Well Name	Well Number	US Well Number	Lease Number	Case Number	Operator
GATO GRANDE 9-	601H	3002551815	NMNM98192	NMNM98192	DEVON
GATO GRANDE 9-	701H	3002551325	NMNM98192	NMNM98192	DEVON
GATO GRANDE 9-	801H	3002551327	NMNM98192	NMNM98192	DEVON

Sundry ID: 2766842

Type of Action: Variance

Procedure Description: Devon Energy Production Co., L.P. (Devon) respectfully requests a variance to break test. Please see attachment.

Section 2 - Blowout Preventer Testing Procedure

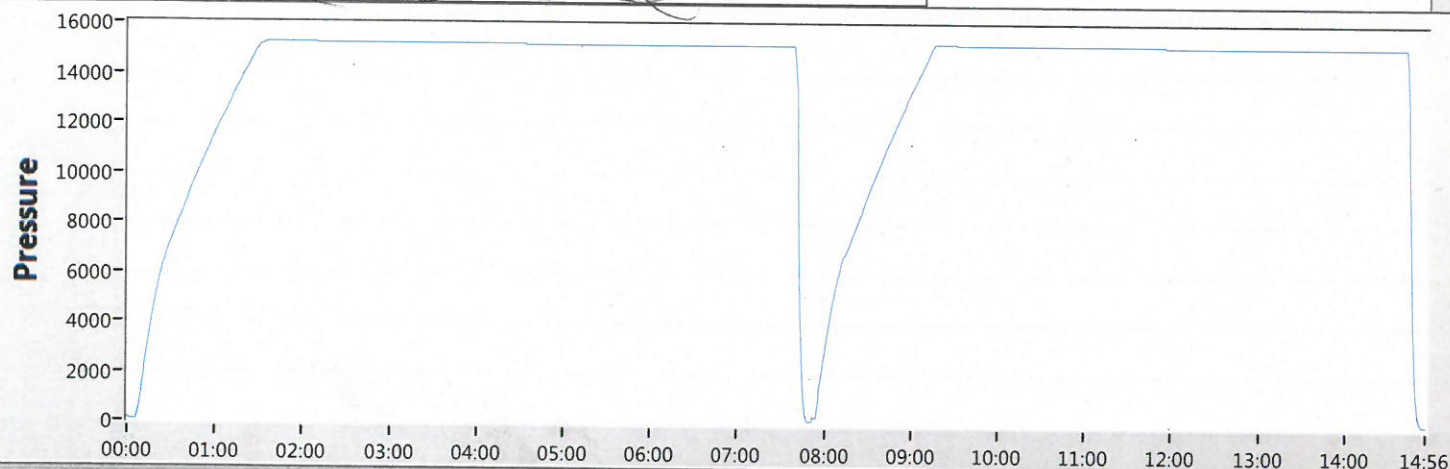
Devon Energy requests to only test BOP connection breaks after drilling out of surface casing and while skidding between wells which conforms to API Standard 53 and industry standards. This test will include the Top Pipe Rams, HCR, Kill Line Check Valve, QDC (quick disconnect to wellhead) and Shell of the 10M BOPE to 5M for 10 minutes. If a break to the flex hose that runs to the choke manifold is required due to repositioning from a skid, the HCR will remain open during the shell test to include that additional break. The variance only pertains to intermediate hole-sections and no deeper than the Bone Springs Formation where 5M BOP tests are required. The initial BOP test will follow OOGO2.III.A.2.i, and subsequent tests following a skid will only test connections that are broken. The annular preventer will be tested to 100% working pressure. This variance will meet or exceed OOGO2.III.A.2.i per the following: Devon Energy will perform a full BOP test per OOGO2.III.A.2.i before drilling out of the intermediate casing string(s) and starting the production hole, before starting any hole section that requires a 10M test, before the expiration of the allotted 14-days for 5M intermediate batch drilling or when the drilling rig is fully mobilized to a new well pad, whichever is sooner. We will utilize a 200' TVD tolerance between intermediate shoes as the cutoff for a full BOP test. The BLM will be contacted 4hrs prior to a BOPE test. The BLM will be notified if and when a well control event is encountered. Break test will be a 14 day interval and not a 30 day full BOPE test interval. If in the event break testing is not utilized, then a full BOPE test would be conducted.

1. Well Control Response:
 1. Primary barrier remains fluid
 2. In the event of an influx due to being underbalanced and after a realized gain or flow, the order of closing BOPE is as follows:
 - a) Annular first
 - b) If annular were to not hold, Upper pipe rams second (which were tested on the skid BOP test)
 - c) If the Upper Pipe Rams were to not hold, Lower Pipe Rams would be third

All Previous COAs Still Apply. Variance request procedure is approved as written, please see below general conditions for variance.

- **BOPE Break Testing is ONLY permitted for 5M BOPE or less. (Annular preventer must be tested to a minimum of 70% of BOPE working pressure and shall be higher than the MASP)**

- **BOPE Break Testing is NOT permitted to drilling the production hole section.**
- **Variance only pertains to the intermediate hole-sections and no deeper than the Bone Springs formation.**

- **While in transfer between wells, the BOPE shall be secured by the hydraulic carrier or cradle.**
- **Any well control event while drilling require notification to the BLM Petroleum Engineer (575-706-2779) prior to the commencement of any BOPE Break Testing operations.**

- **A full BOPE test is required prior to drilling the first deep intermediate hole section. If any subsequent hole interval is deeper than the first, a full BOPE test will be required. (200' TVD tolerance between intermediate shoes is allowable).**

- **The BLM is to be contacted (575-689-5981 Lea County) 4 hours prior to BOPE tests.**
- **As a minimum, a full BOPE test shall be performed at 21-day intervals.**

- **In the event any repairs or replacement of the BOPE is required, the BOPE shall test as per 43 CFR part 3170 Subpart 3172.**
- **If in the event break testing is not utilized, then a full BOPE test would be conducted.**
